ENGINE - FUEL AND CONTROL - REPLACE THE TUBE CLIP AT CLIPPING POINT 0795 - CATEGORY
CODE 4 - MOD.ENG-73-0021

V2500-ENG-73-0021

Location at clipping point 0795
Fig.1

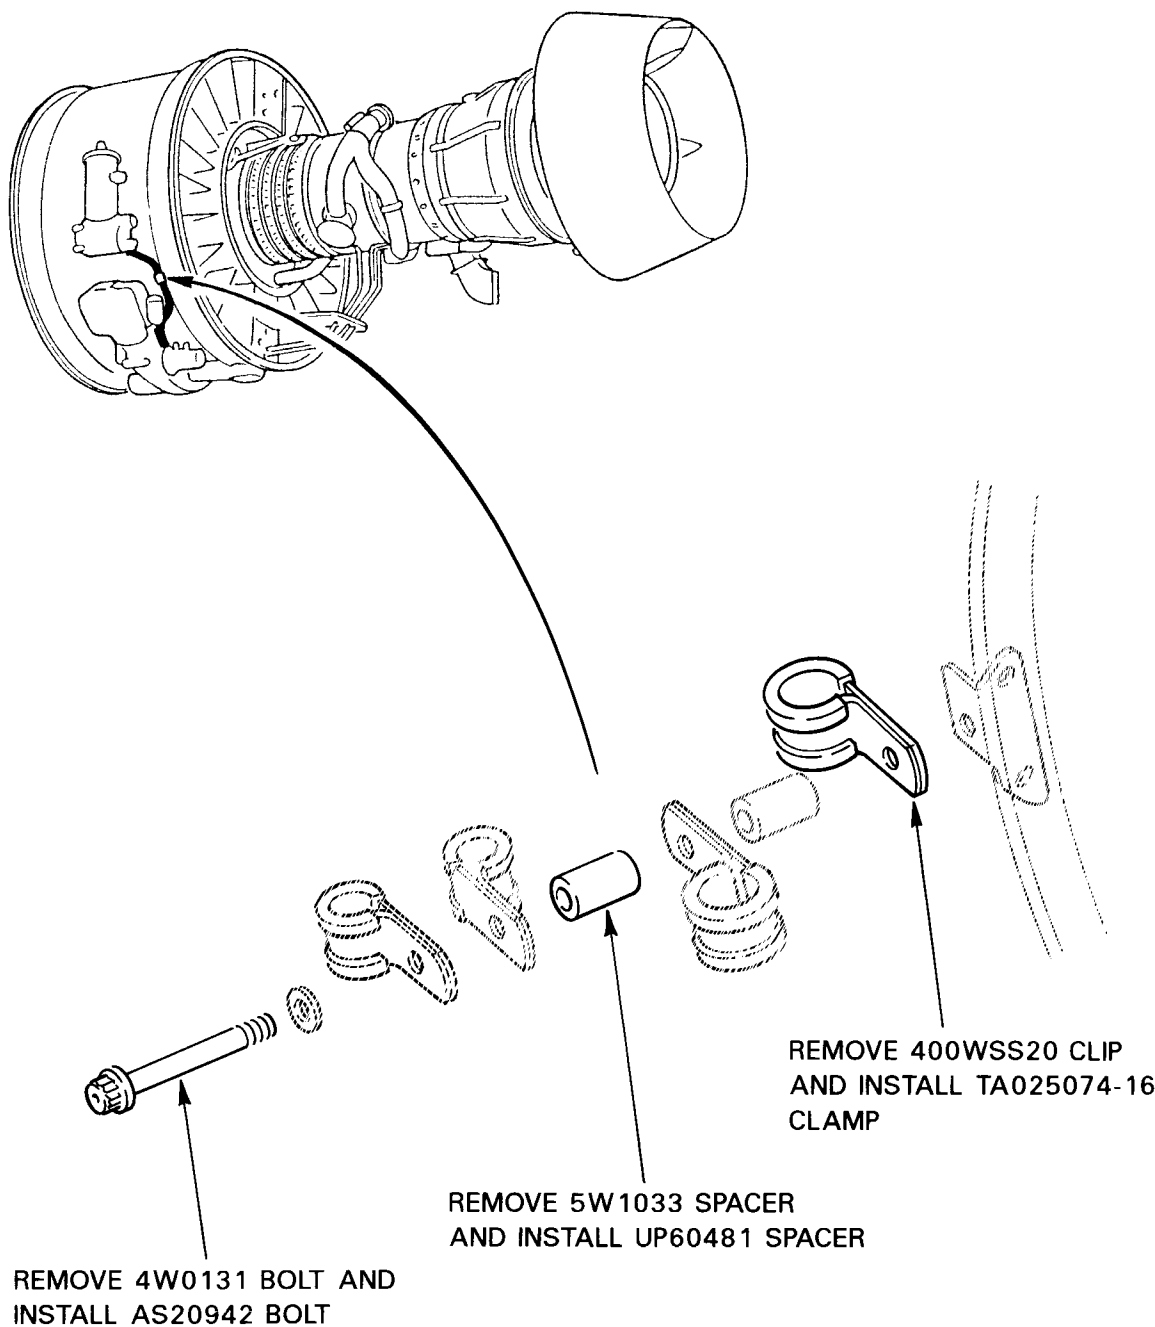
Fretting could occur on the fuel cooled oil cooler (F.C.O.C.) to fuel pump fuel tube in the area of clipping point 0795.

An instance of fretting between the 'P' clip at clipping point 0795 and the fuel tube has been reported.

The fretting results from relative movement between the clip and tube, the metal clip eventually wearing through the rubber sleeve to fret directly on the tube. The movement is permitted due to loose a fit of the clip on the tube.

View of clipping point 0795 - Before and after alteration
Fig.2

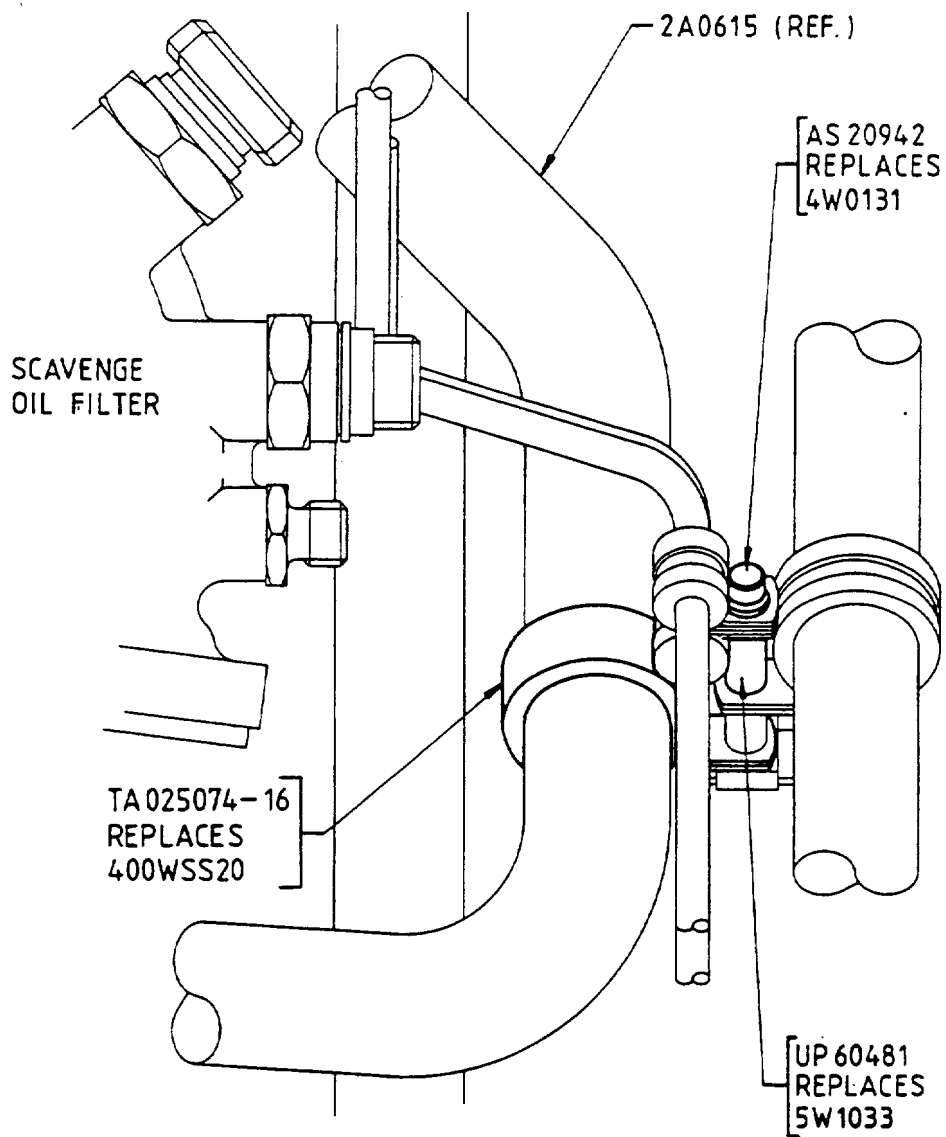
- (a) A tube clamp with a thicker rubber sleeve replaces the existing clip at clipping point 0795. The new clamp has a tighter fit with the tube compared to the existing clip.
- (b) A longer spacer is introduced to avoid fouling between the new clamp and adjacent tubes and a longer bolt is introduced to accommodate the longer spacer.

- (1) Secure the F.C.O.C. to fuel pump fuel tube to clipping point 0795 using clamp TA025074-16, bolt AS20942, washer AN960XC10L, spacers UP60481 and 5W1032 and nut 4W0043 (refer to Figure 2).
